MINOR PROJECT REFINEMENT REQUEST FORM

Request Number: 04
Date Requested: September 16, 2022
**Proposed Duration/
Timing of Use:** Upon approval through October 15, 2022
Daytime hours
Location: Pole 96 Anchor and guywire relocation
APN: 017-031-013-000
Attached Map? Yes No

Client/Project 185705825
PG&E Humboldt Bay-Humboldt #1 60kV
MPR 04

Title
Pole 96 - Anchor Move and Tree Trimming

Figure
1

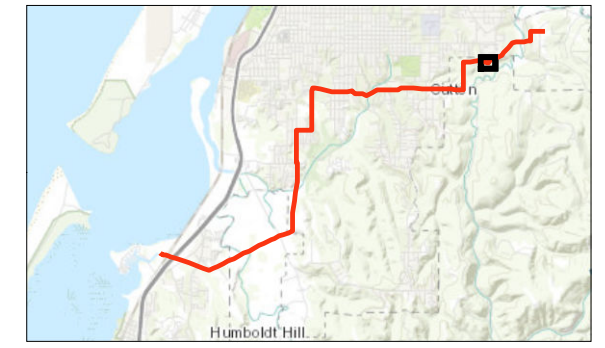
PG&E proposes to re-locate the anchor and guywire associated with Pole 96. Due to unanticipated geotechnical considerations resulting in pole subsidence, PG&E proposes to replace the existing pole and to move the anchor and guy wire approximately 15 feet to the southwest, resulting in 100 square feet of vegetation removal. The resulting minor change in line angle would also necessitate trimming a small redwood tree north of the transmission line to maintain required clearance distance.

PG&E replaced Pole 96 as part of the current project in August of 2022 but due to ground subsidence, it has sunk by approximately three feet, bringing the pole out of engineering standards. The proposed minor project refinement would allow greater support for the pole by means of a more stable pole base and a wider guywire angle.
